RECEIPT DATE: 8-9-19 **ONSITE SEWAGE DISPOSAL SYSTEM** P 5805184
 APPROVAL DATE: 8/21/19 **PERMIT: CONSTRUCTION** A _____
 PROPERTY ADDRESS: 1386 Driver Road
 SUBDIVISION: _____ LOT: 7A TAX ID: _____
 CONTRACTOR: FARM AND HOME EMAIL: _____
 CONTRACTOR ADDRESS: _____ PHONE: _____

RE: BAT Plan
1386 Driver Road, Lot 7A

The following comments refer to the BAT Plan for 1386 Driver Road:

SITE PLAN FOR BAT INSTALLATION

1 SITE PLAN FOR BAT INSTALLATION
 SCALE: 1"=40'

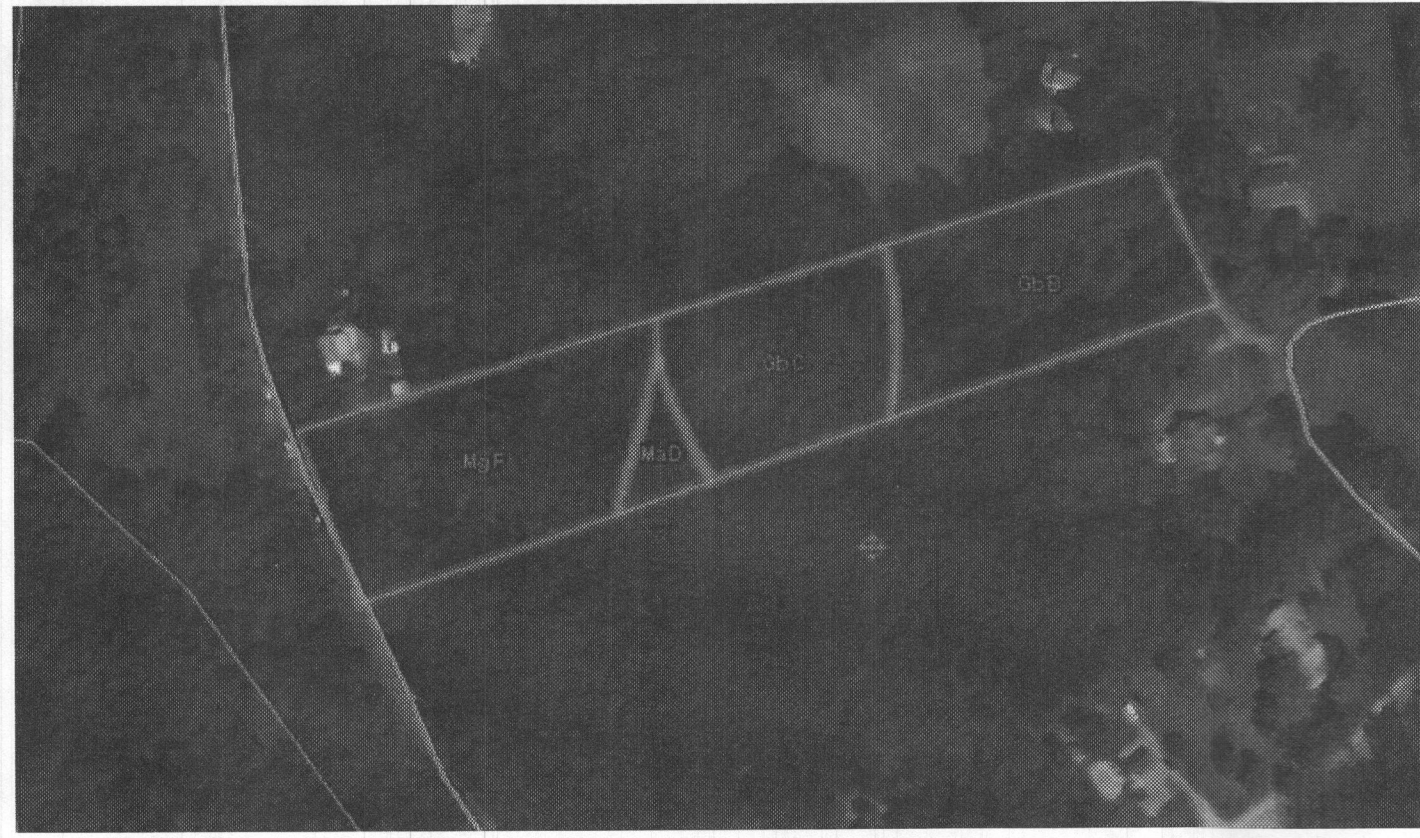
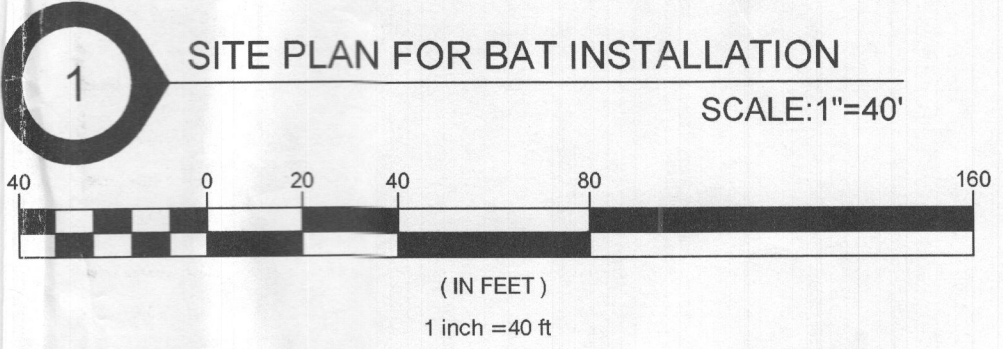
- 1.) The well box location does not match the signed Perc Cert Plan. For example, the well box on the perc cert is 10 feet from lot line on one side of it.
- 2.) Add note: The well tag # HO-15-0046 has been field located and accurately shown.
- 3.) Change wording from "Top of Trench Depth" to "Trench Invert Elevation" in chart.
- 4.) Eliminate any legend symbol not used on plan. For example, "Existing Water Line".
- 5.) Show a minimum of 2 inches of gravel above the trench invert in septic profile and geotextile filter fabric above the gravel. There should be no filter below the trench invert.

12/31/18 - Jeff Wood
came to office to discuss
comments. Also noted
the following:
. Add well radius around
well box.
. match OSDS to PC (ie well box)
. Need original S & M agreement.

- 1.) Add a note that the existing well tag # has been field located by NAME of Engineer or Surveyor on DATE.
- 2.) Add well tag # to first page of plan next to existing well.
- 3.) Add legend symbol for existing well
- 4.) Add legend symbol for Sewage Disposal Area (SDA)
- 5.) Show calculations for all 3 systems
- 6.) Show how all 3 systems (i.e. trenches) fit within the approved SDA. Please utilize the SDA as efficiently as possible starting at the very top with the first trench.
- 7.) Add a trench side profile for first system.
- 8.) Raise tank as high as possible while maintaining 2% fall and 6 inches cover and raise the distribution box and trench inverts as high as possible while maintaining 2% fall and 18 inch invert depth.

- 1. The location of the well box has been revised to match the Perc Certification Plan.**
- 2. Well tag note has been added.**
- 3. The Top of the Trench depth has been revised in the cahrt.**
- 4. Unused items in the legend have been removed.**
- 5. 2" filter and geo-textile filter fabric has been added and noted on the profile of the septic trench.**

Note:
 The well tag # HO-15-0046 has been field located and accurately shown.

DETAILS AND NOTES

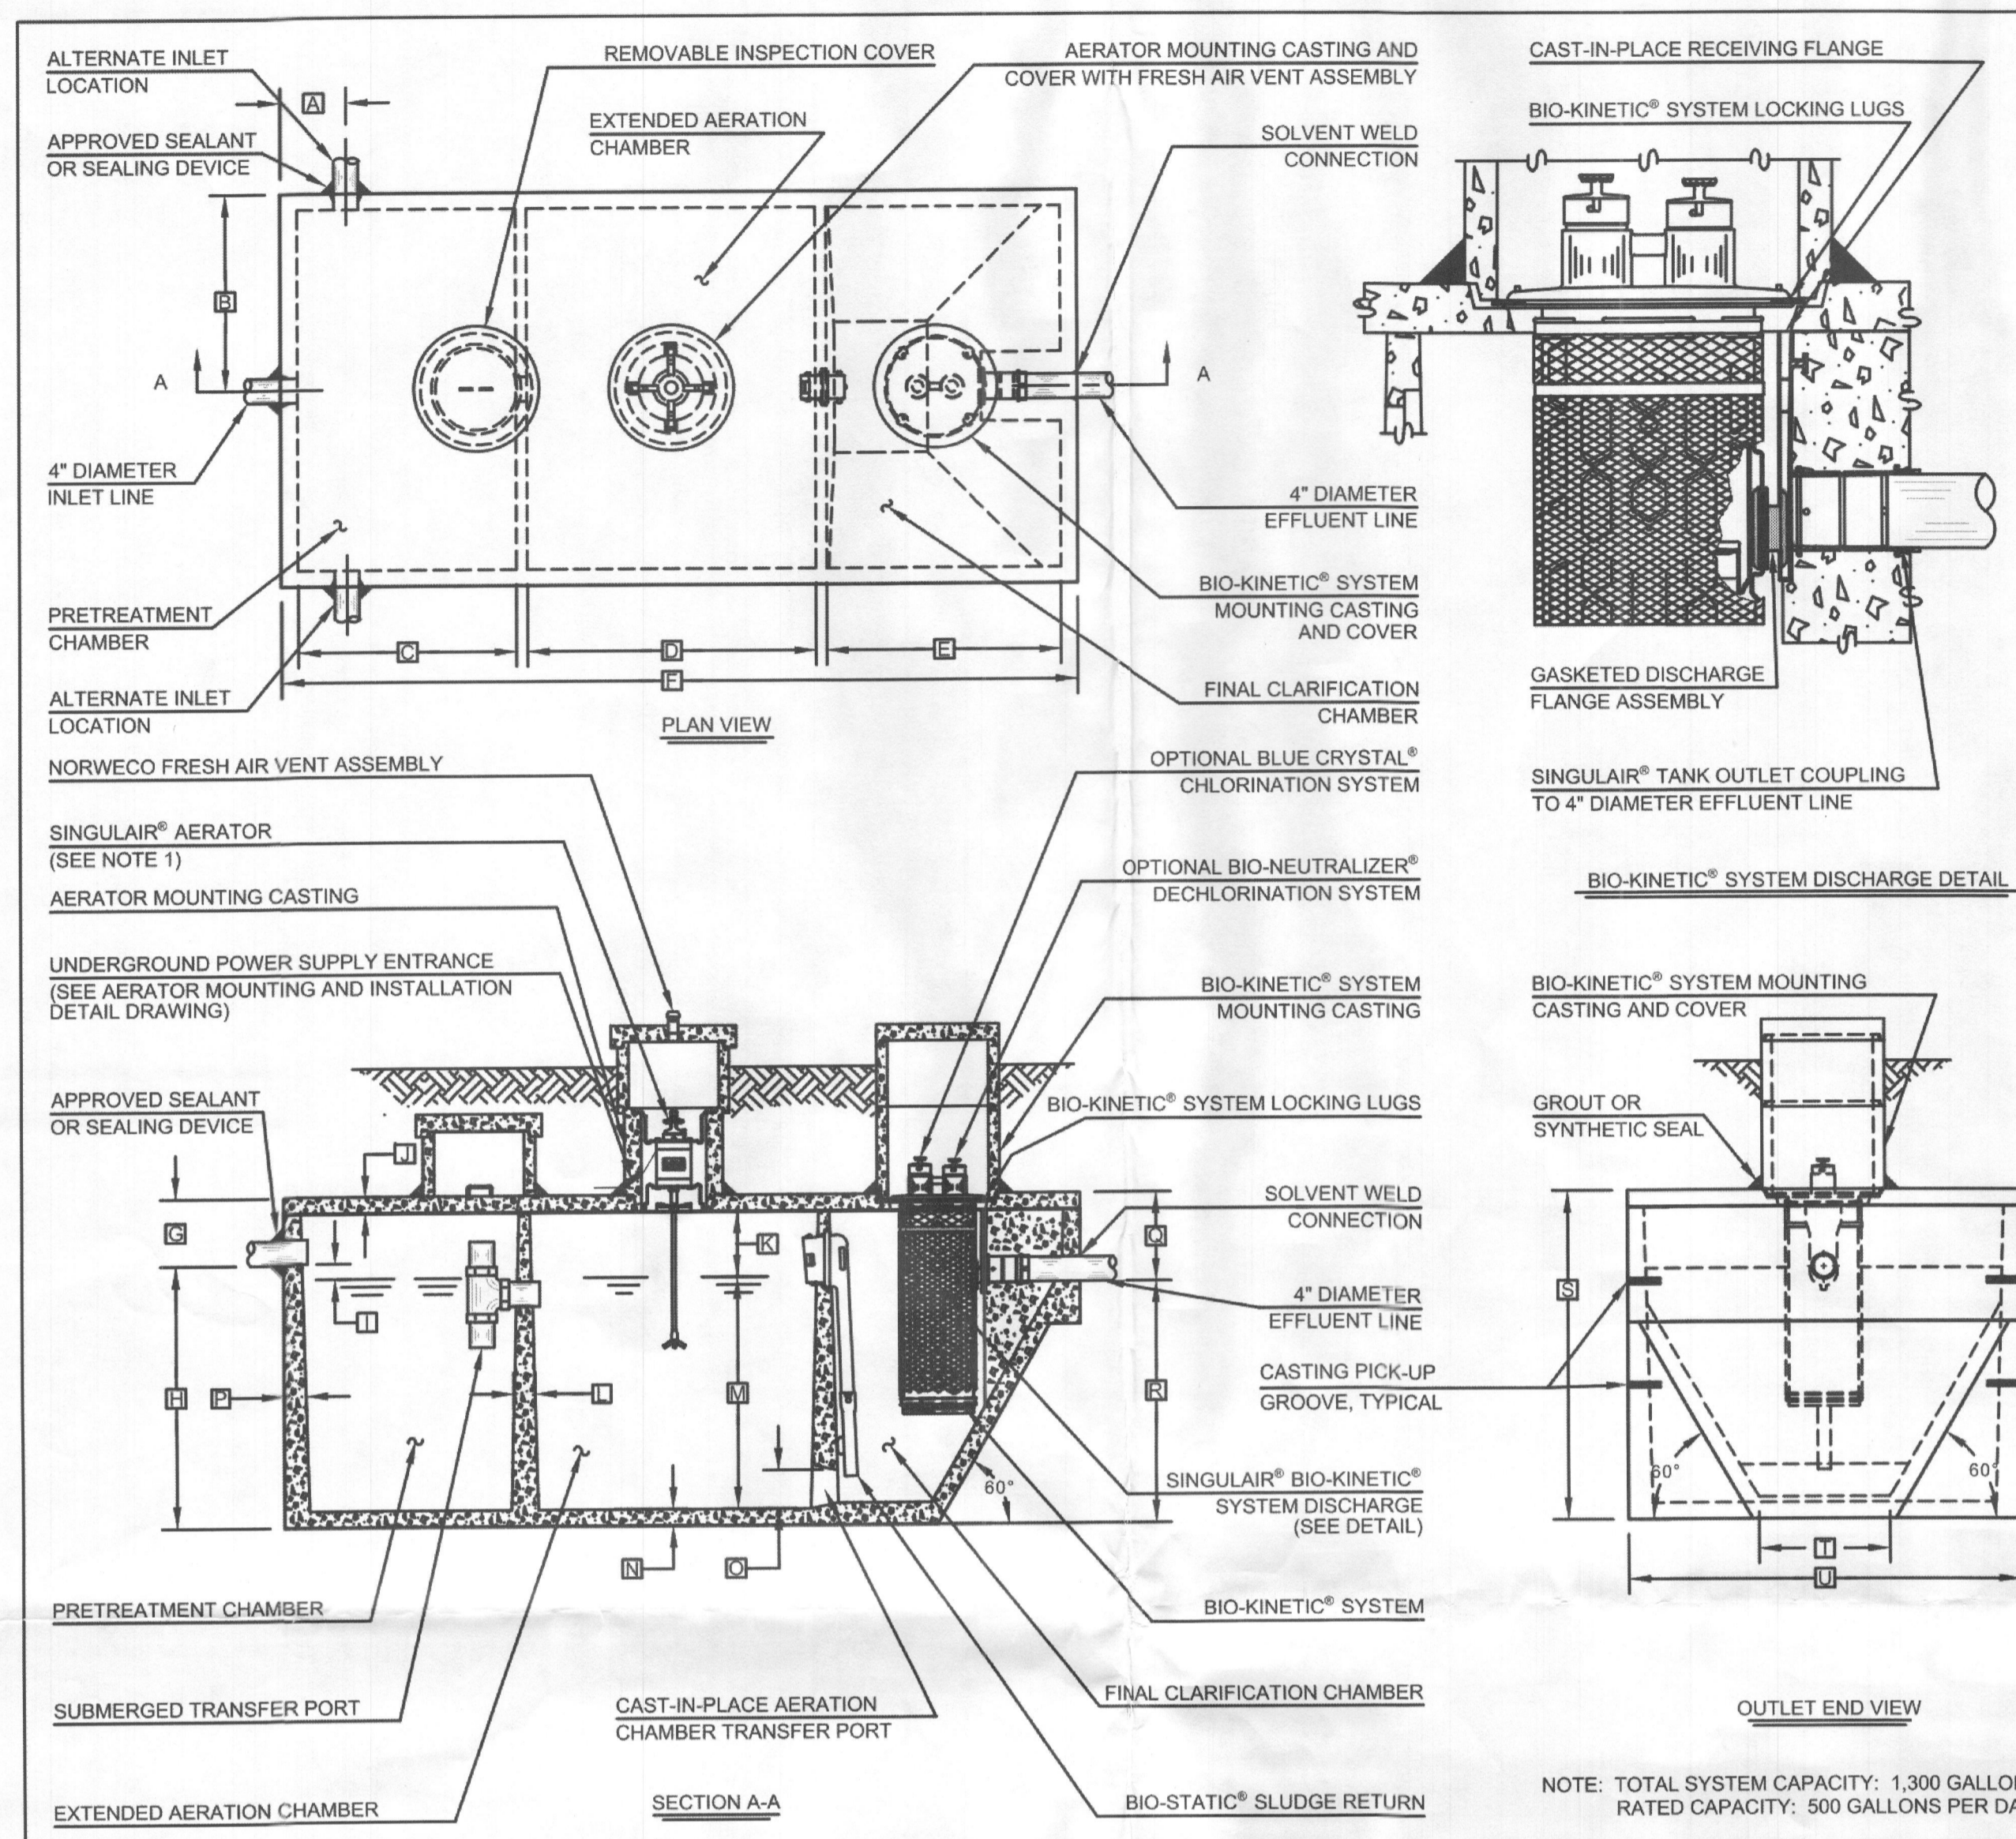
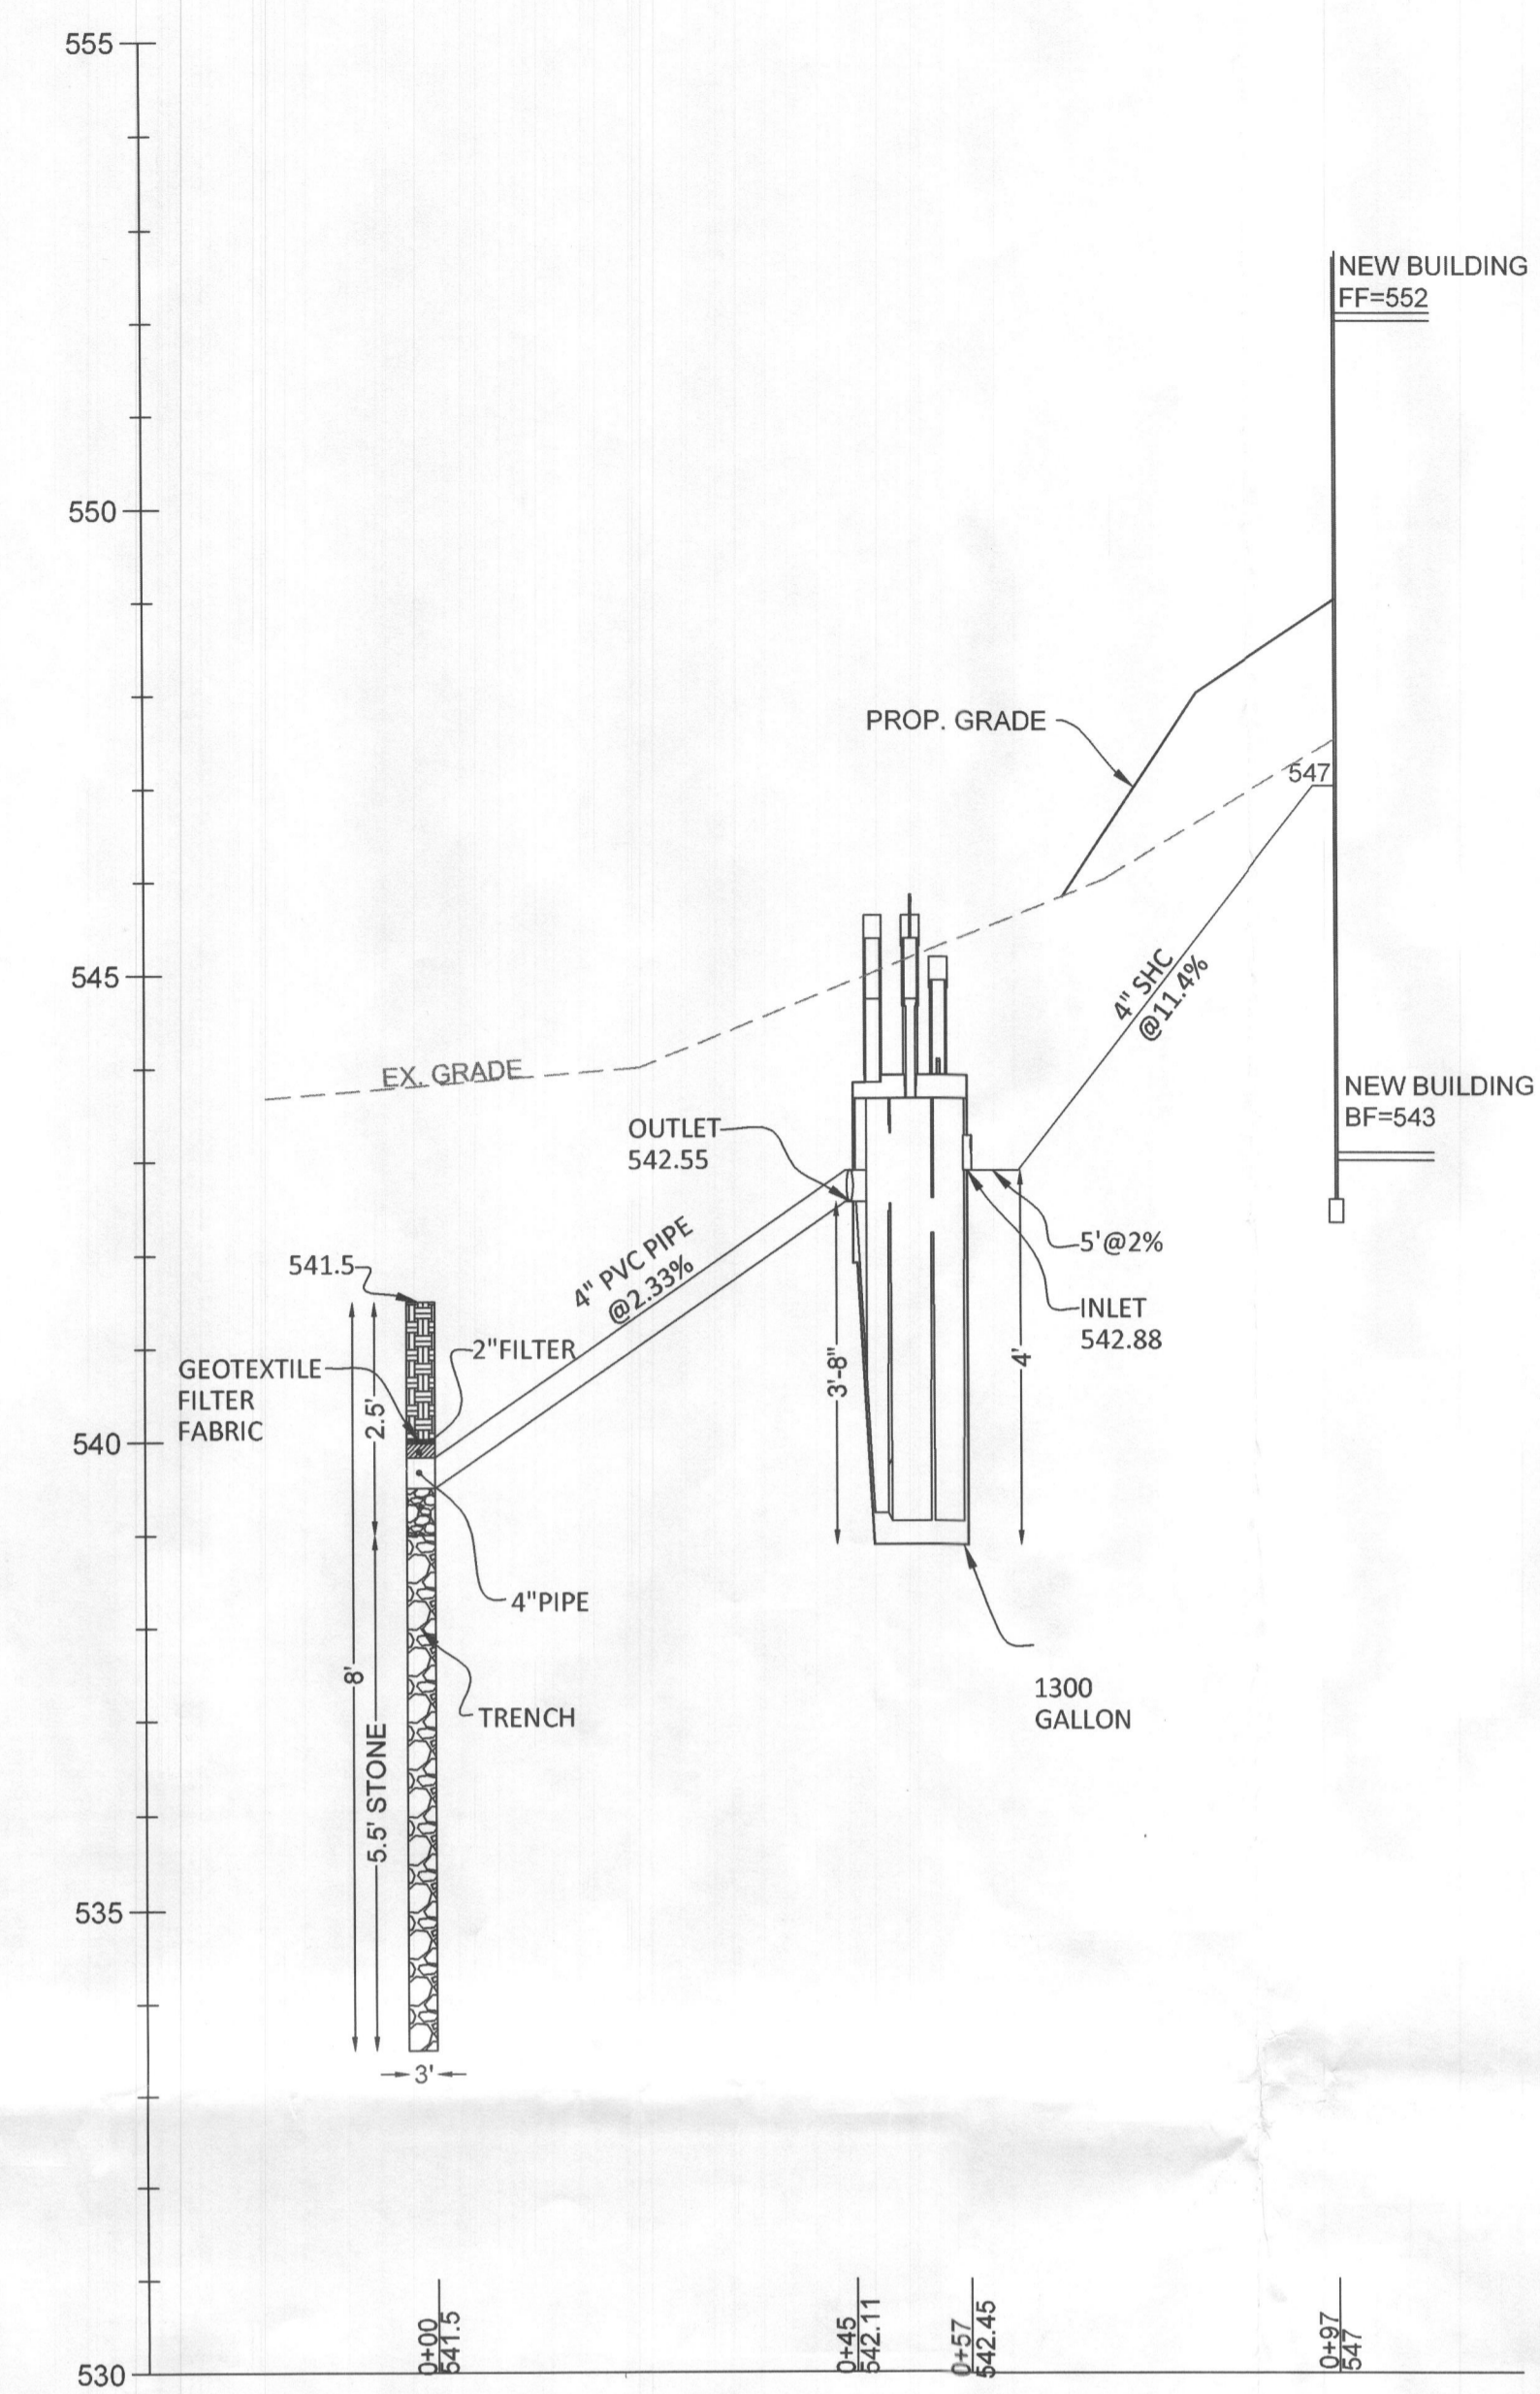
Yes, 82.5 feet is correct for a 4 BR house. As I mentioned, the unfinished basement shows potential for a 5th bedroom. You may want to size the system for 5 bedrooms. You will need to show the trench layout on the plan starting at the top of the SDA. You also need a septic and trench profile with elevations.

Revised Septic Design Plan is attached . Profile for sewer to tank and BAT has been added. Plan is now 2 sheets.
